PLAN COMMISSION / ZONING BOARD OF APPEALS AGENDA

Project: Abbey Woods North
Meeting Type: Public Hearing
Requests: Rezoning (upon annexation), Preliminary Plat of Subdivision, relief from Design Standards for cul-de-sac length and wall length, relief from Land Subdivision Regulations for cul-de-sac length and stub street connection, review of variations for lot width & depth
Location: South side of St. Francis Road, just east of La Grange Road
Applicant: O'Malley Builders Inc.
Prop. Owner: Steven Beemsterboer
Representative: Shawn O'Malley
Staff Reviewer: Christopher Gruba, Senior Planner

ABBEY WOODS NORTH
STEVEN BEEMSTERBOER
9433 ST FRANCIS ROAD FRANKFORT, ILLINOIS
PRELIMINARY PLAT

VILLAGE OF FRANKFORT
PROPOSED HICKORY CREEK BIKE PATH
TOPOGRAPHIC EXHIBIT

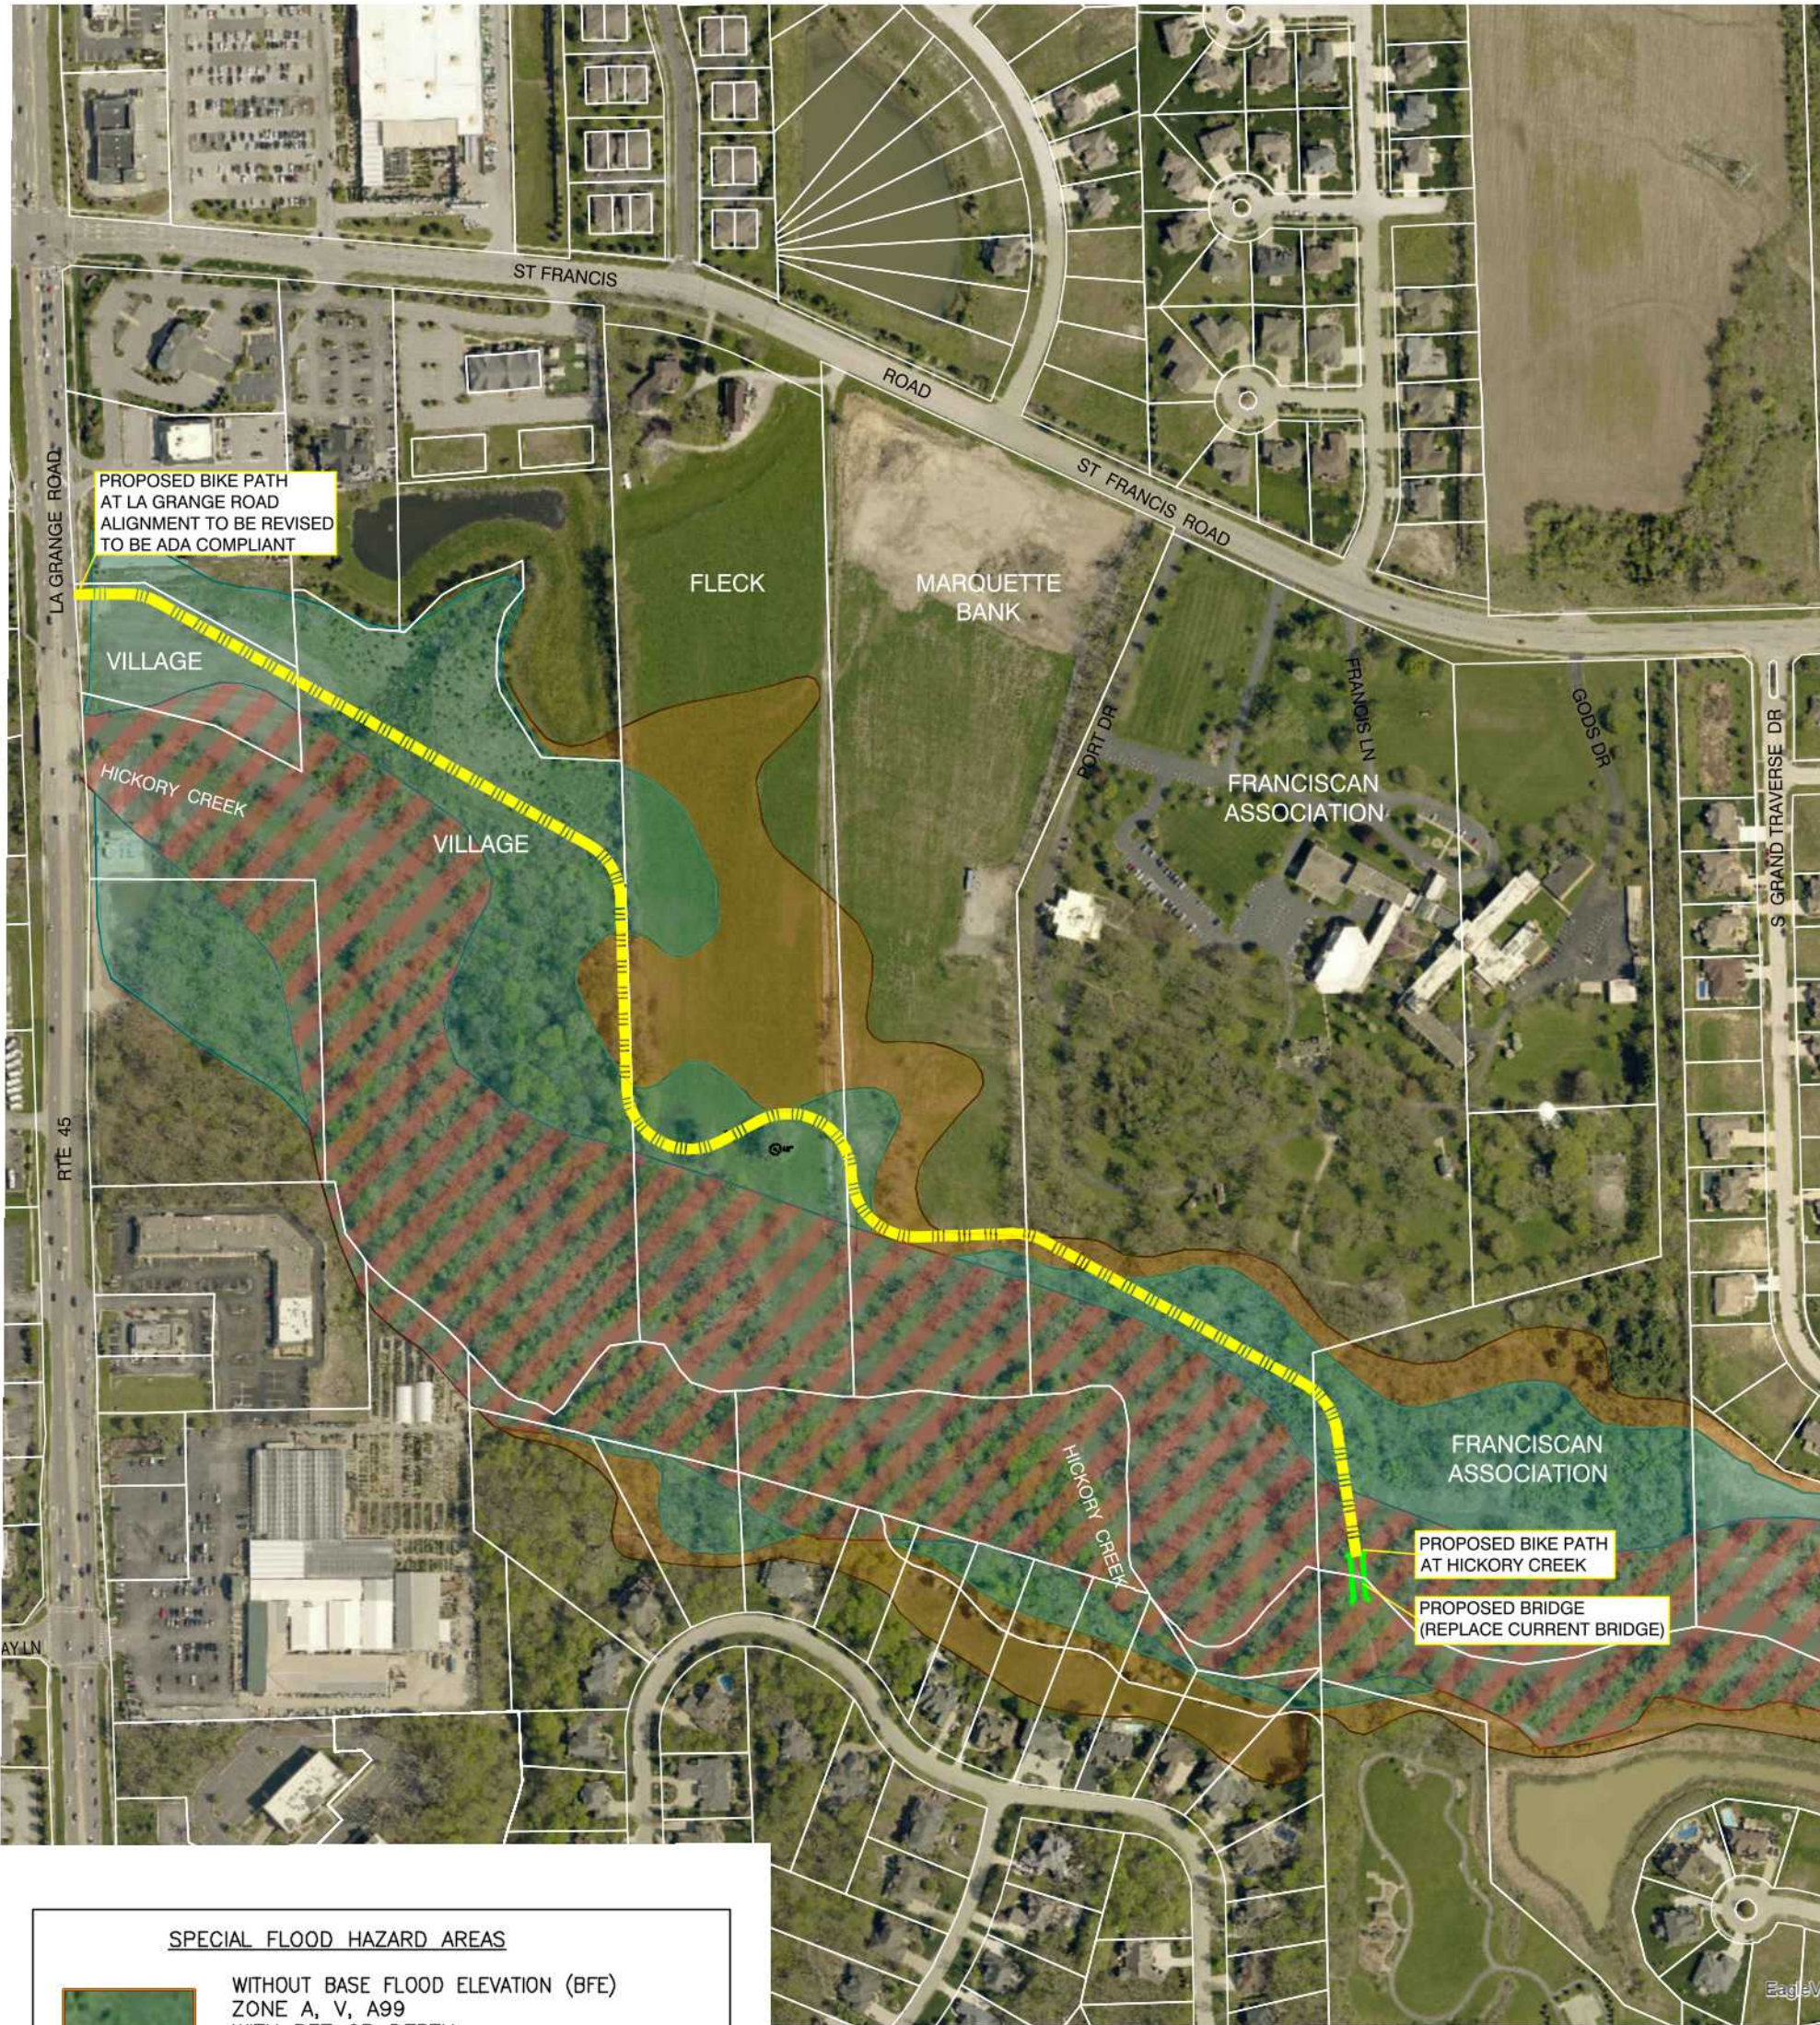
5. In 2019, the Village drafted preliminary planning documents for a future bike path along the north side of Hickory Creek from La Grange Road near Dollar Tree to an older pedestrian bridge near Lighthouse Pointe Park (see attached exhibit). The bike path crosses through the subject property at the south end, close to Hickory Creek, and would be the first segment of the path to be completed. At staff's request, the applicant has provided a 10' wide bike path connection, closely matching the preliminary plans for the route of the bike path and would allow a future connection to properties on either side. The bike path would be located in a common area within part of Outlot A, to be owned and maintained by the HOA. The bike path would also connect to the cul-de-sac right-of-way, making it accessible to residents of the subdivision. The general public could also access the bike path via St. Francis to the Waterview Trail extension. The proposed retaining walls would not interfere with the bike path.

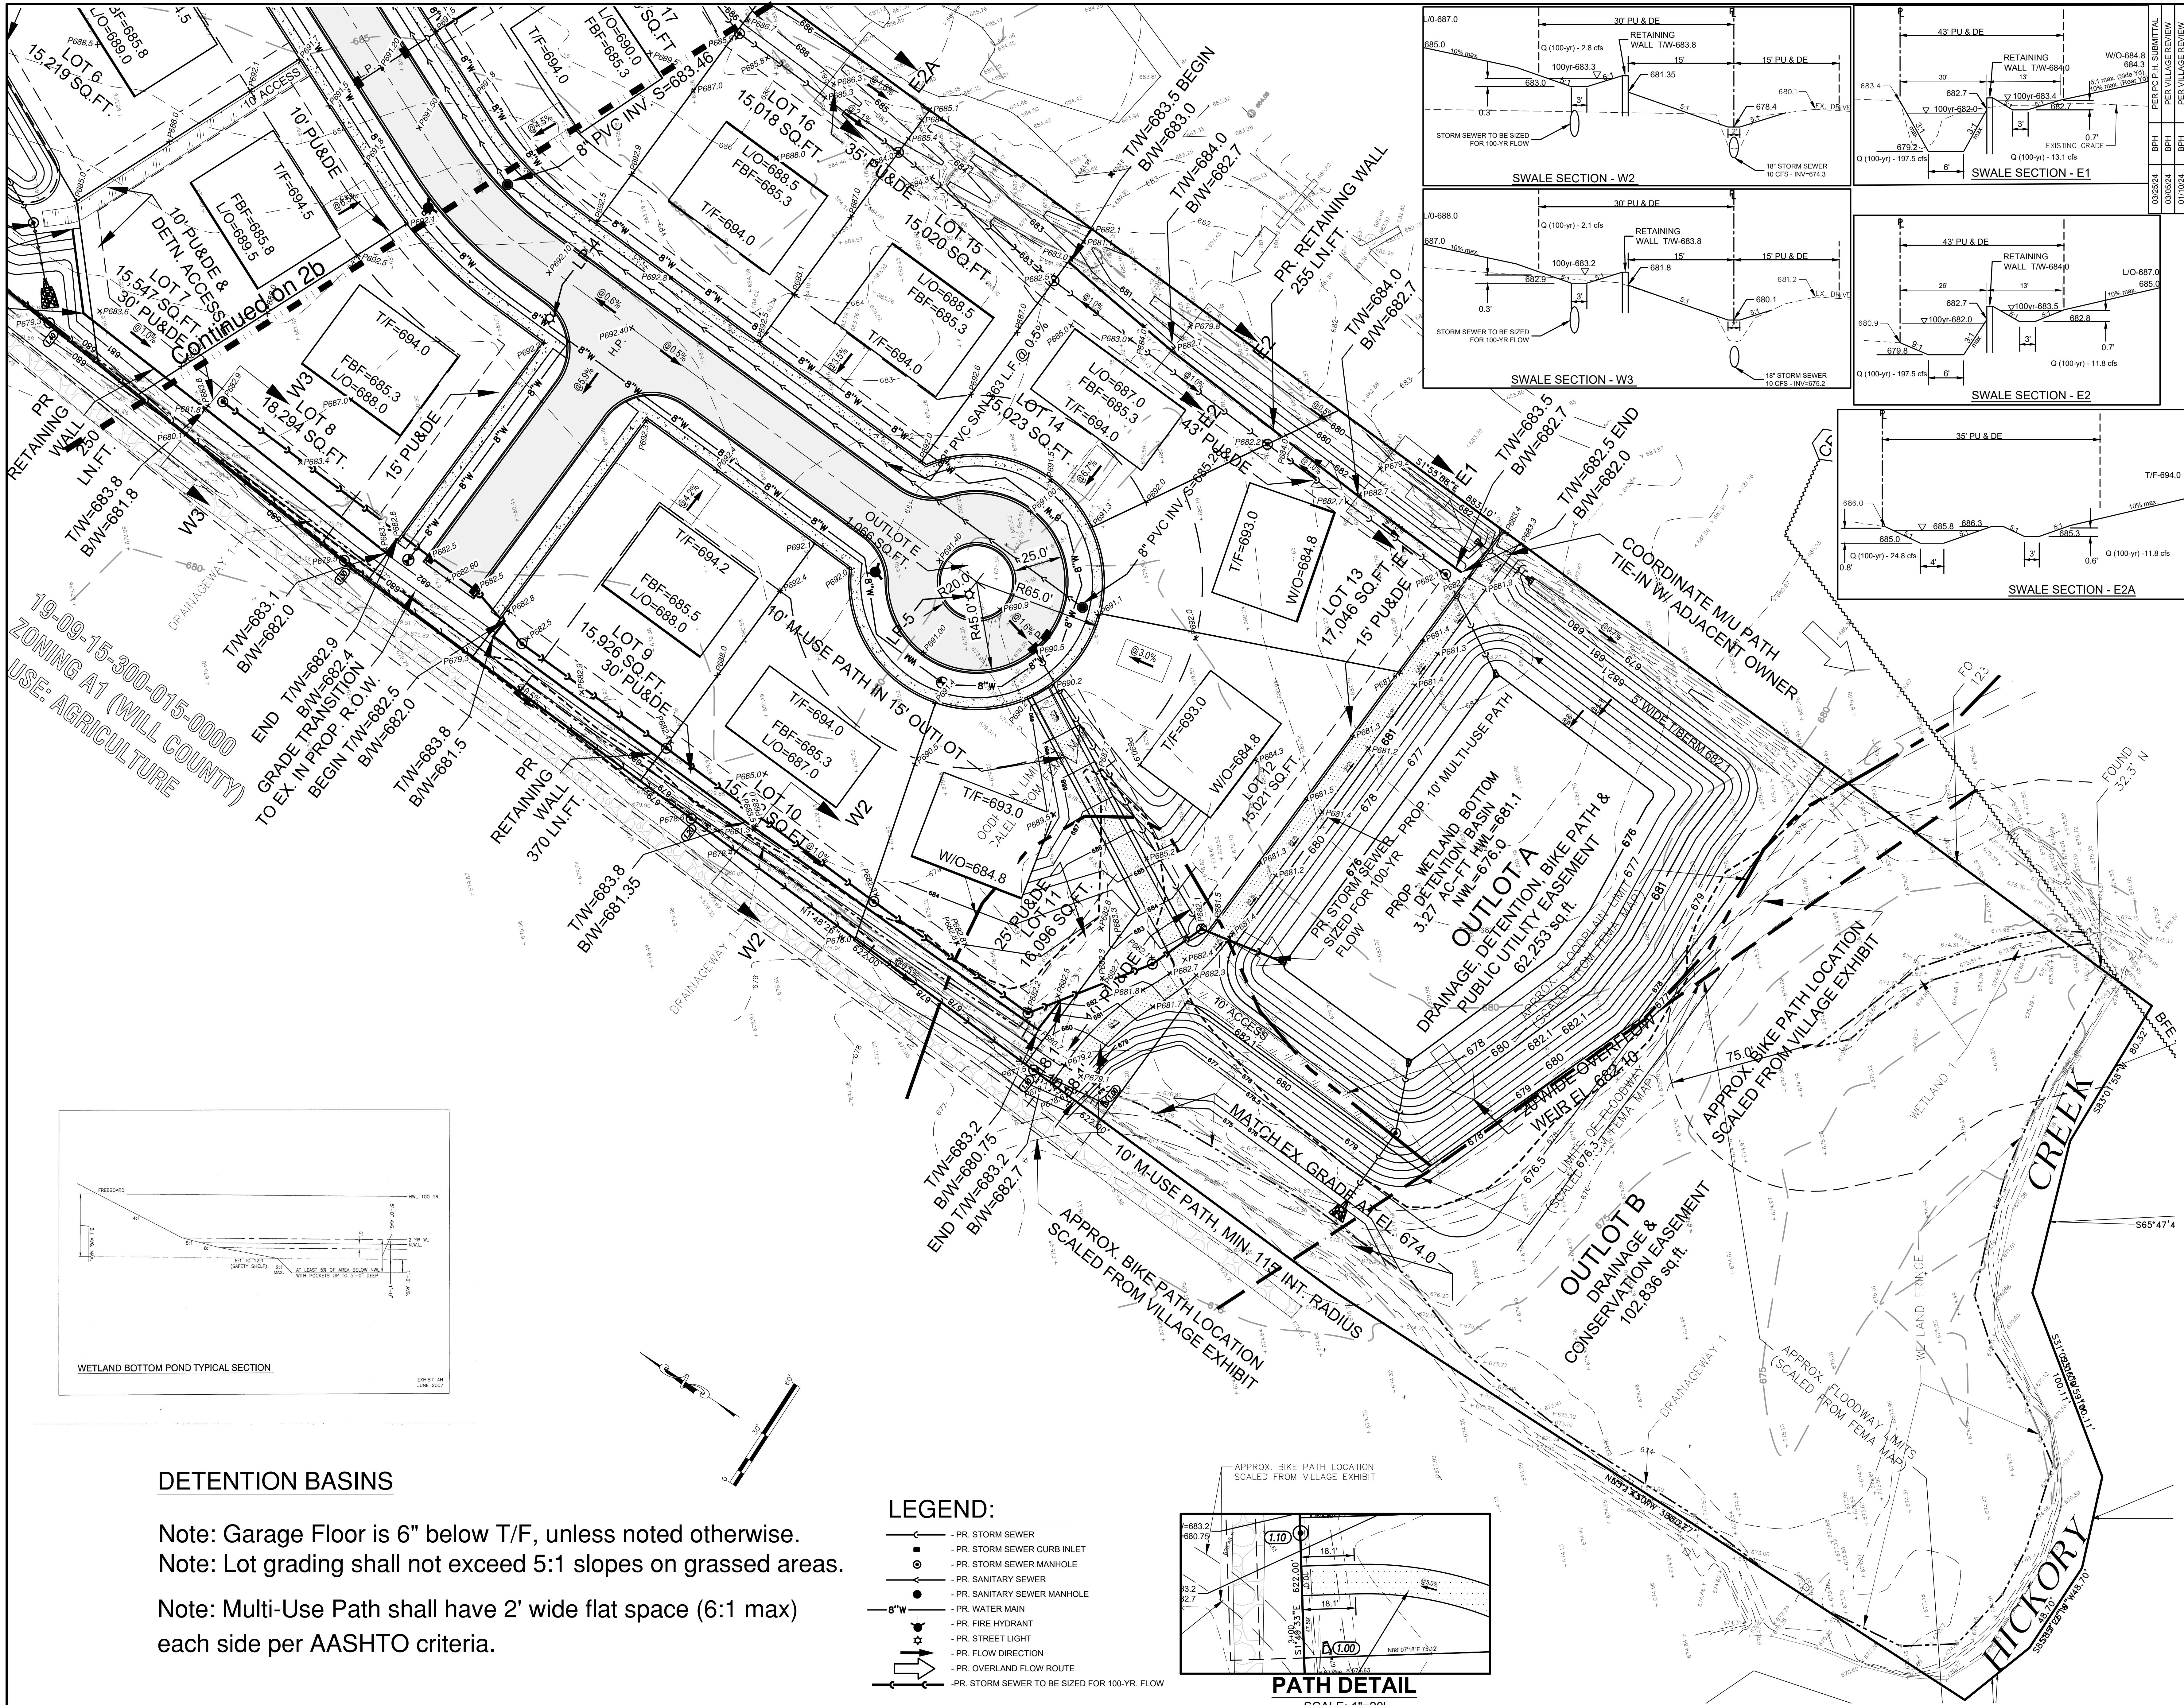
1. The former plans illustrated a drainage swale upon and along the entire west property line that eventually emptied into Hickory Creek. The revised plans illustrate the same swale along the west property line adjacent to the detention pond on "Outlot C", but water would now be directed into an underground stormwater pipe with catch basins at regular intervals. The stormwater pipe would eventually drain into Hickory Creek the same as before. Although this seems like a minor change, it has the impact of being able to remove the swale south of the detention pond on "Outlot C", allowing the land above to be flattened out and raised. This in turn results in lower retaining walls along the west property line, within the boundaries of Lots 7-11 and the west retaining wall was reduced from 5.6' to a maximum height of 2.45'. More importantly, by funneling the stormwater into an underground pipe, it removes the need for a box culvert beneath the stub street, which are expensive and require maintenance over time.

3. During a meeting with the applicant on April 2nd, the applicant agreed that the Preliminary Plat should be revised to include a "no fence" easement between the retaining wall and the west property line for Lots 7-11. This was done to ensure proper drainage and because it would have made lawn mowing challenging between the wall and the fence along the rear property line. For example, if a fence was installed along the side and rear property lines on Lot 10, a lawn mower would need to be lifted over the 2.45' tall wall to reach the furthest extent of the backyard. A revised Plat of Subdivision was not available at the time of this report.

9. The applicant is requesting several variations for this project, including but not limited to providing less than the minimum required lot widths and depth. In response, staff recommended to the applicant to investigate whether either of the adjacent property owners would consider conveying (selling) a portion of their land to provide greater flexibility of site design, such as meeting the minimum lot depth requirement. The applicant has informed staff that neither adjacent property owner is interested in selling a portion of their property.

7. Recommend the Village Board approve a variation request to reduce the minimum corner lot width to 106.8' instead of 120' for Lot 8, which may be included as part of the Annexation Agreement for Abbey Woods North, in accordance with the reviewed plans, public testimony and findings of fact.

8. Recommend the Village Board approve a variation request to reduce the minimum corner lot width to 106.2' instead of 120' for Lot 9, which may be included as part of the Annexation Agreement for Abbey Woods North, in accordance with the reviewed plans, public testimony and findings of fact.

9. Recommend the Village Board approve a variation request to reduce the minimum corner lot width to 106.6' instead of 120' for Lot 25, which may be included as part of the Annexation Agreement for Abbey Woods North, in accordance with the reviewed plans, public testimony and findings of fact.

10. Recommend the Village Board approve a variation request to reduce the minimum lot depth to 123.1' instead of 150' for Lot 10, which may be included as part of the Annexation Agreement for Abbey Woods North, in accordance with the reviewed plans, public testimony and findings of fact.
